Agenda Item 3
846 Northmoor Road
Second Story Addition and Exterior Alterations

846 Northmoor Road

Continued consideration of a request for approval of a second floor addition and various exterior alterations to a single family home.

PROPOSED SITE PLAN & IMPERVIOUS SURFACE CALCULATIONS

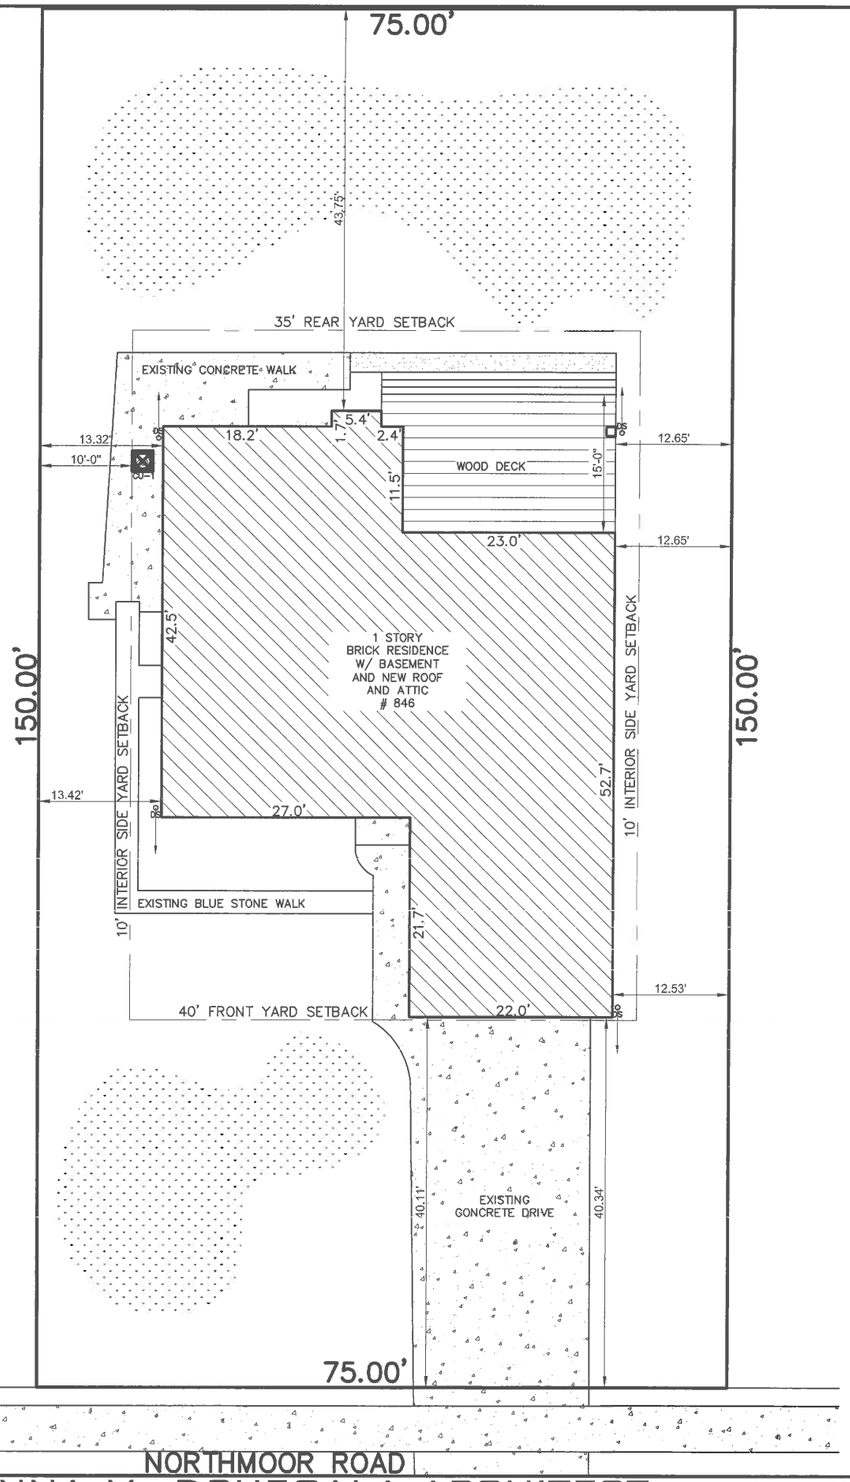
Site Plan – This standard is met.
The original footprint of the house and garage will be maintained. The existing siting of the house is generally aligned with the other homes on Northmoor Road. The new covered deck is proposed on the rear of the house. An extension of the sidewalk along the rear of the house is also proposed. No changes are proposed to the existing curb cut or driveway.

CURRENTLY PROPOSED NORTH ELEVATION

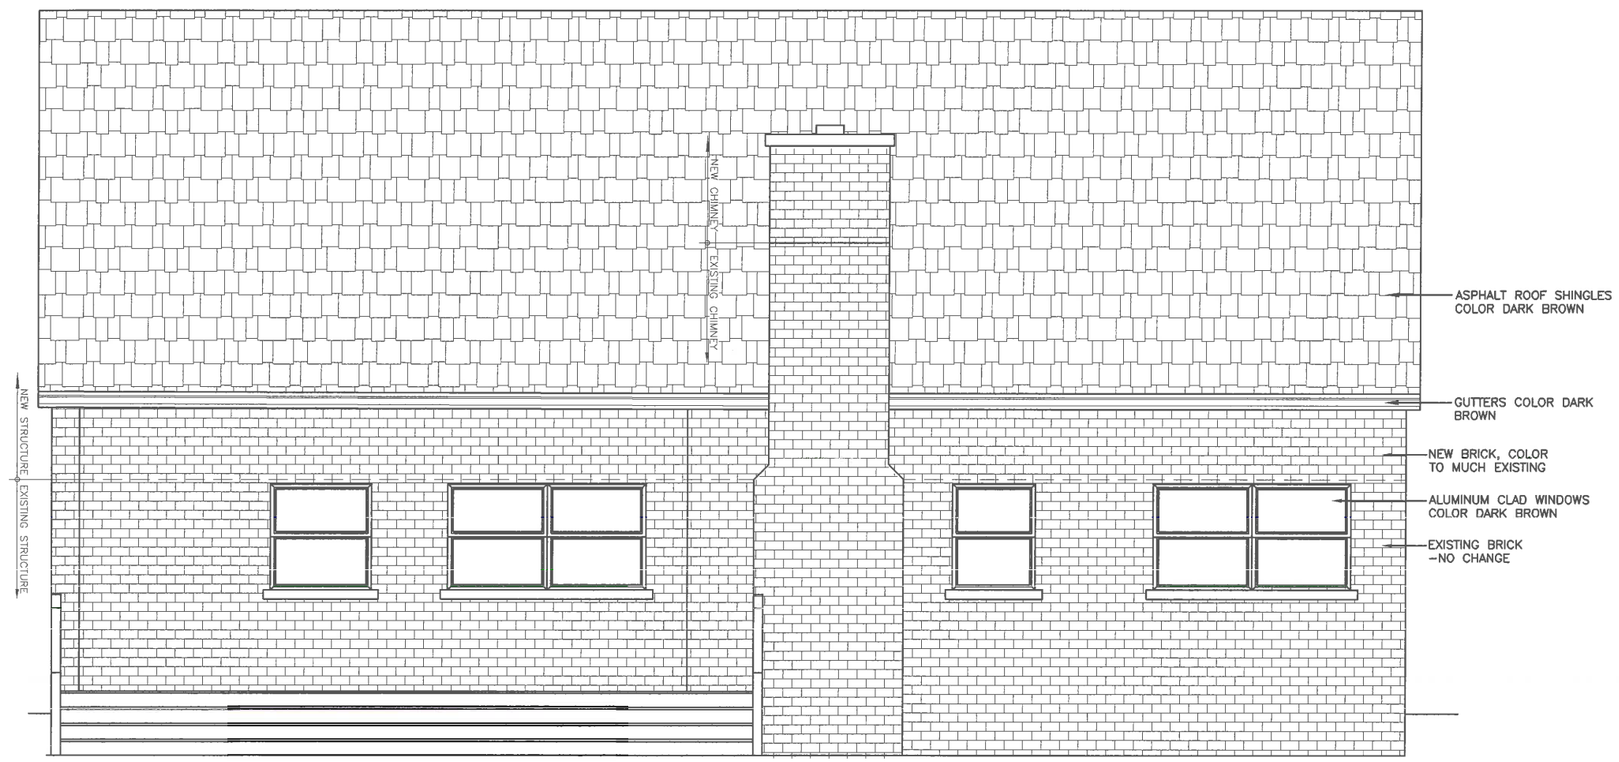
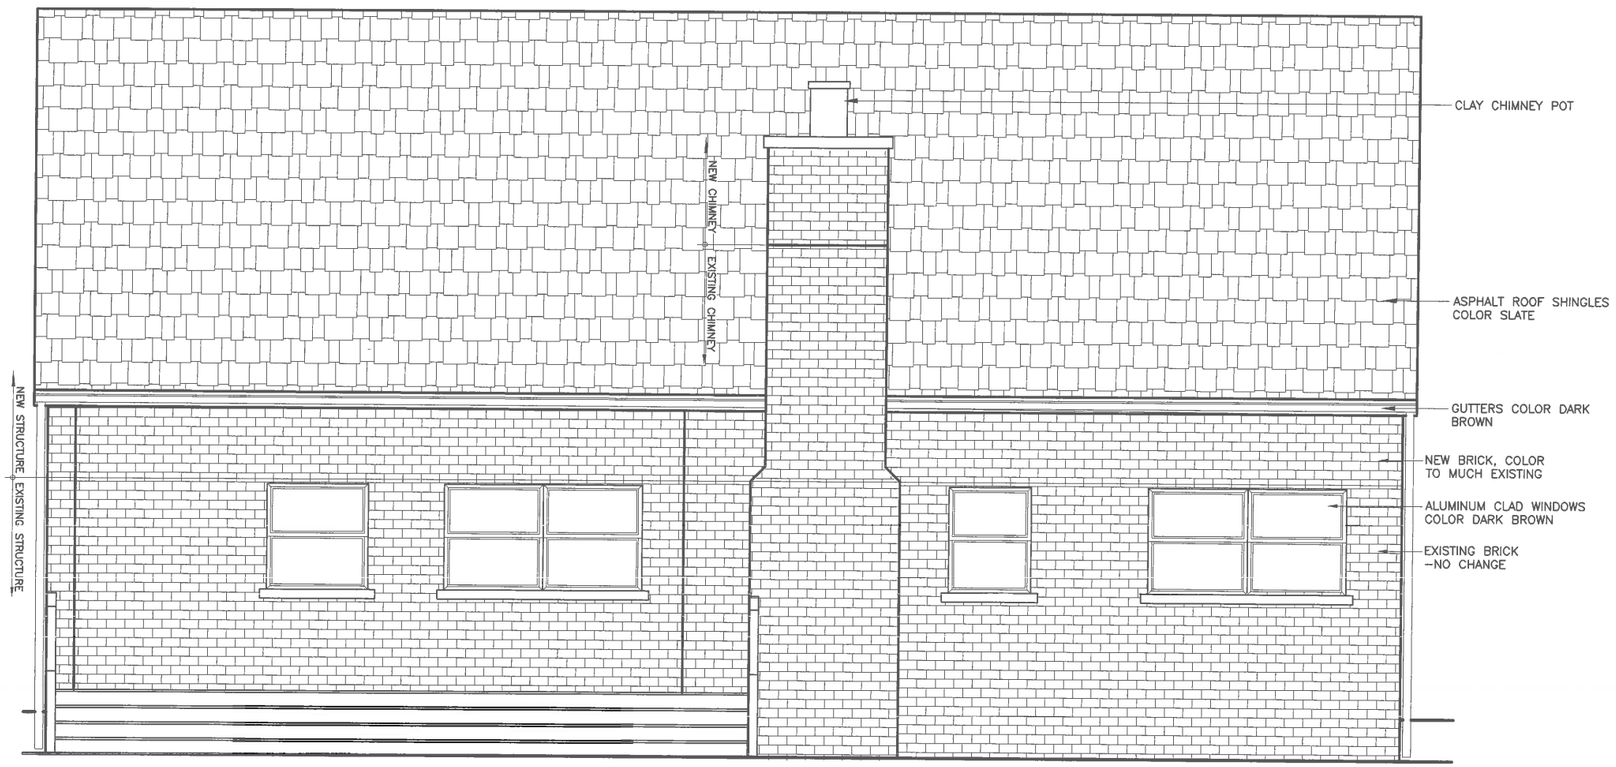
- The existing door and stoop on the rear will be removed.
- A new single window will be installed in the existing door opening, and will be filled in below with brick.
- The existing window openings on the rear will remain, and replacement windows will be installed.
- A covered deck is proposed on the east side of the rear elevation.
- The existing chimney will remain and will be extended to meet Code requirements.
- A clay chimney pot is reflected on the elevation drawing.

CURRENTLY PROPOSED EAST ELEVATION

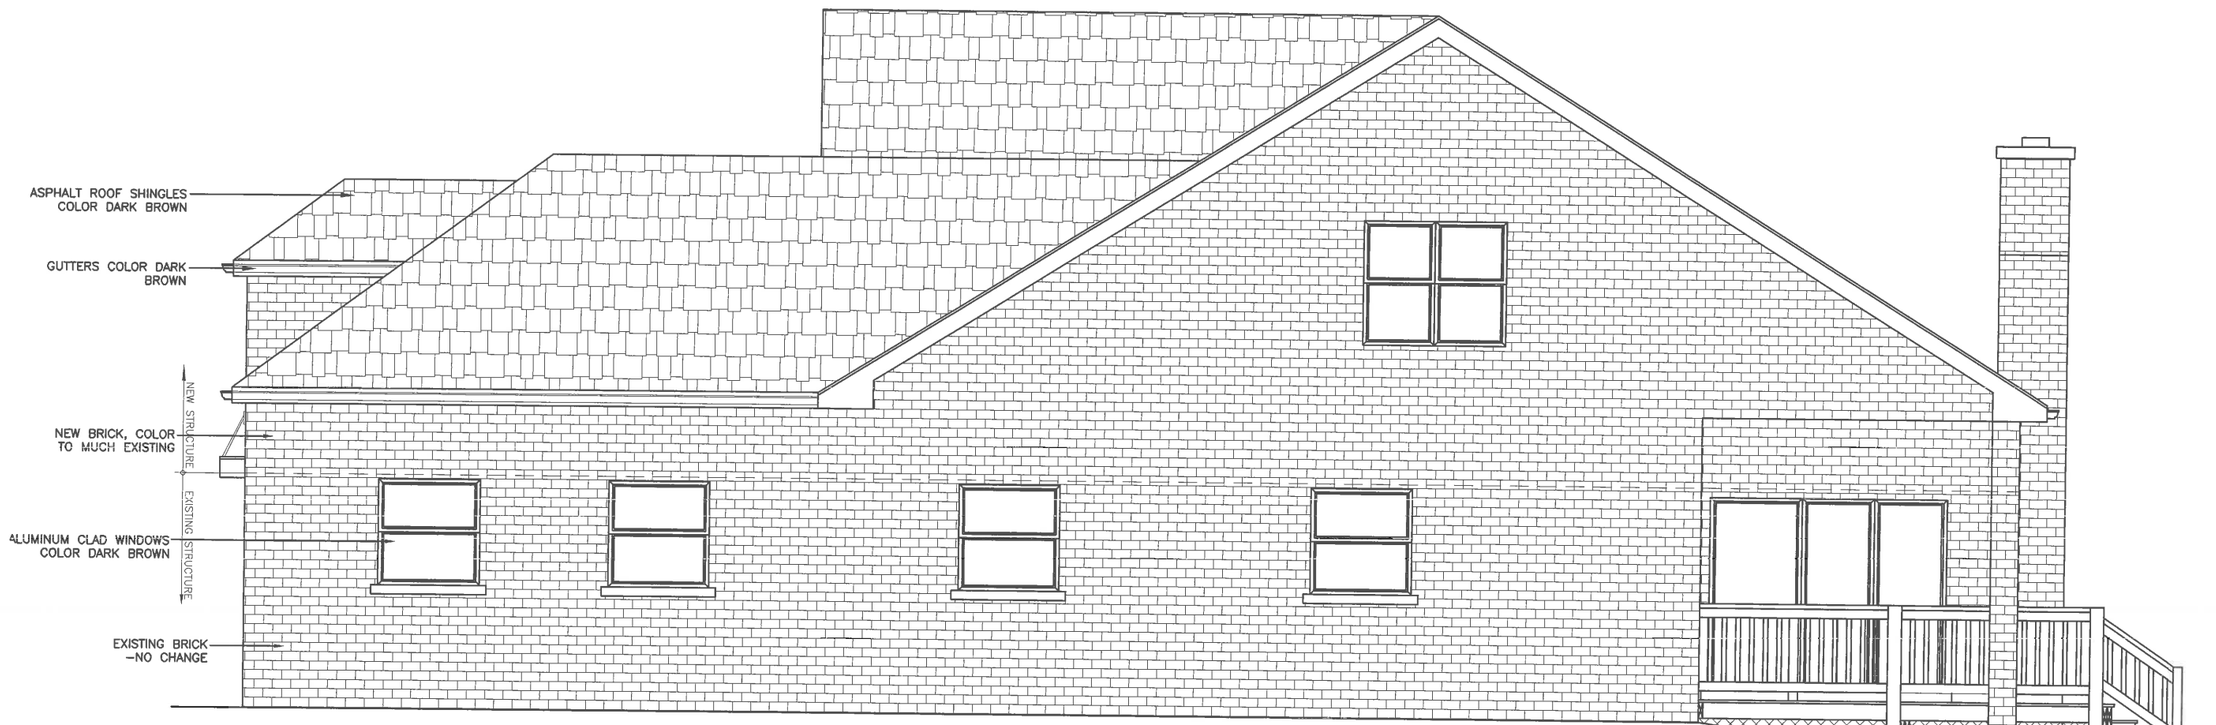
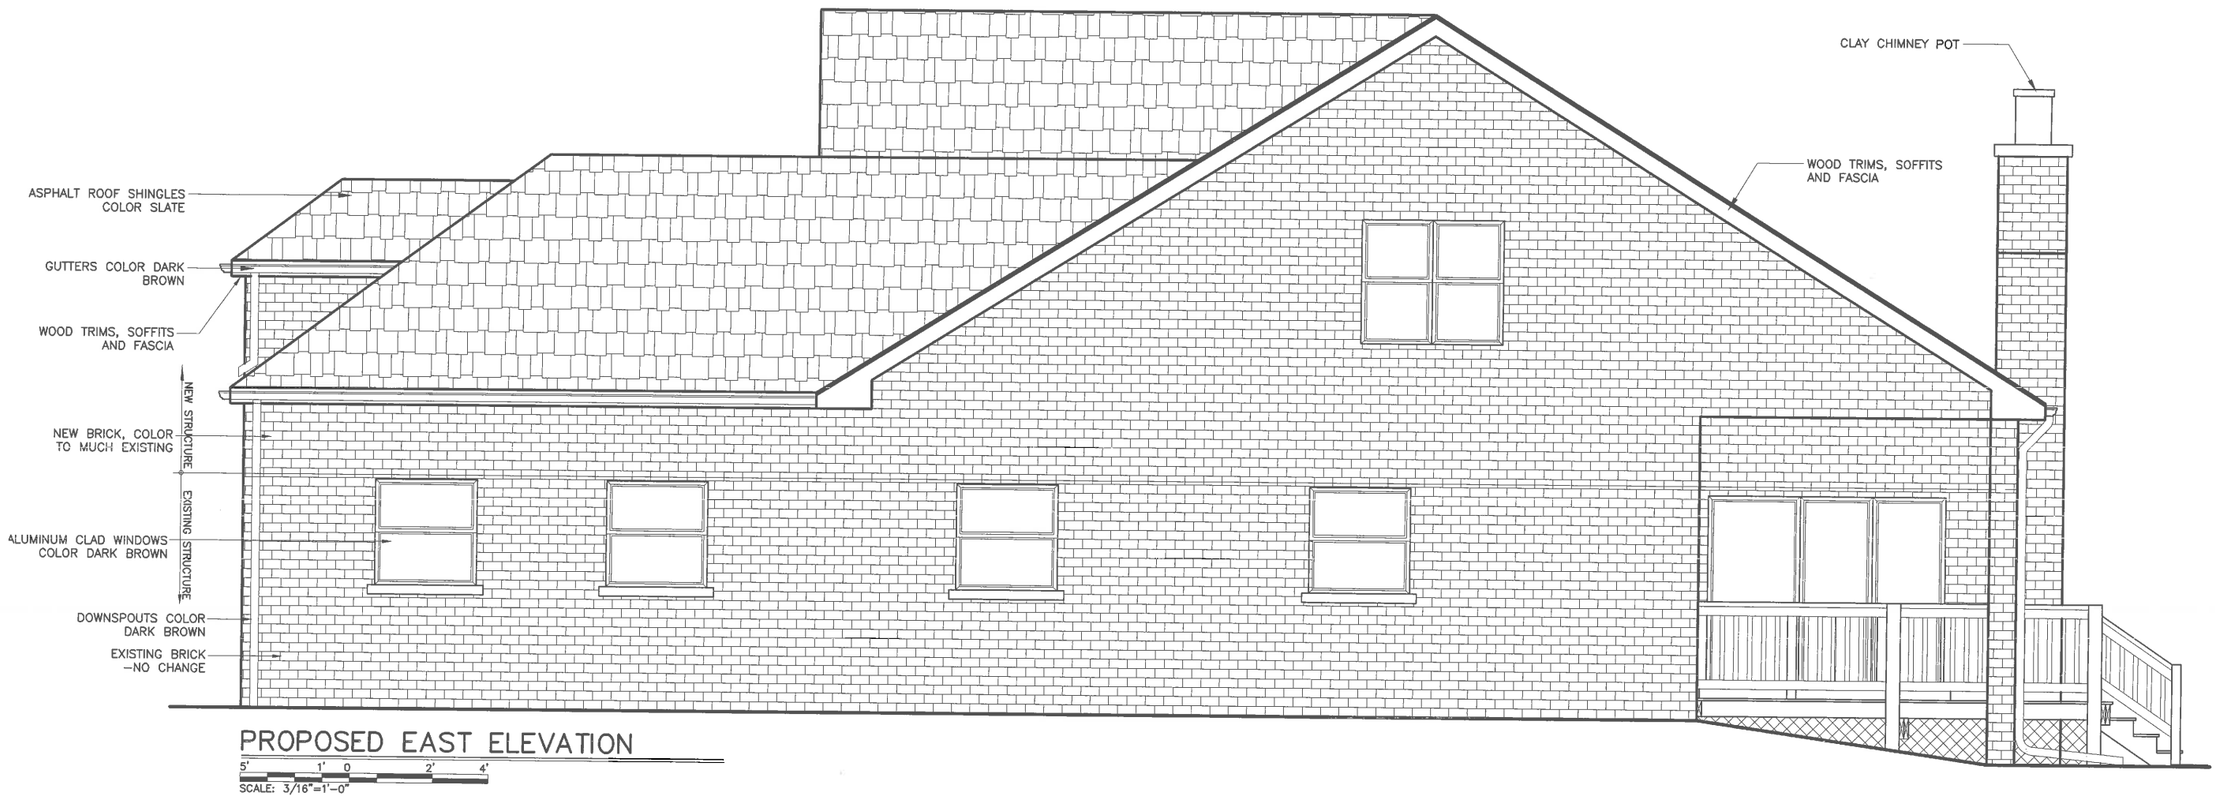
- The proposed east elevation features a large gable form with a double window in the center.
- The large existing windows on the north end will be replaced with a sliding glass door accessing the new deck.
- The single window openings on the elevation will remain and will have replacement windows. The existing double window opening will be modified for a new single replacement window.

CONCEPTUAL LANDSCAPE PLAN

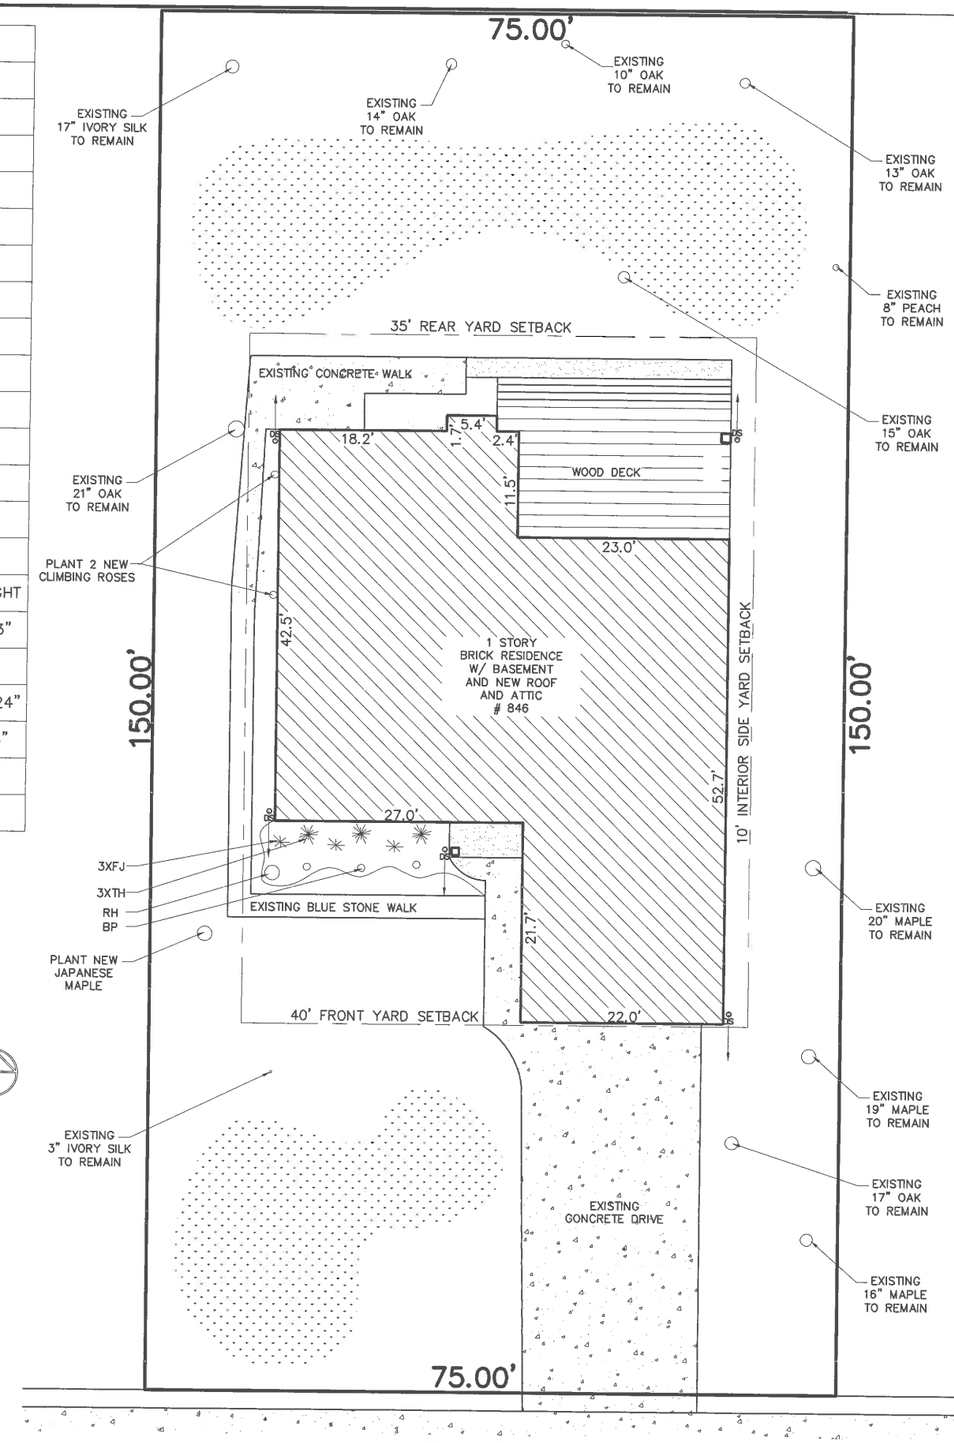
In response to comments made at the last meeting, the petitioner has prepared a conceptual landscape plan. The landscape plan reflects shrub and ornamental type plantings along the front of the house. A Japanese maple is also proposed at the front of the house. The addition of one larger tree could be helpful in softening the impact of the increased mass of the house over time.

3. A final landscape plan shall be submitted and shall reflect additional plantings in the front yard to soften the appearance of the additional mass. The plan will be subject to review and approval by the City's Arborist.

7. The landscaping will not changed, all existing trees will be protected and remained. On the front of the house few new shrubs and ground covers will be planted. On the west elevation where windows will be removed new climbing roses will be planted and wood trellis will be installed to break up the large solid brick wall.
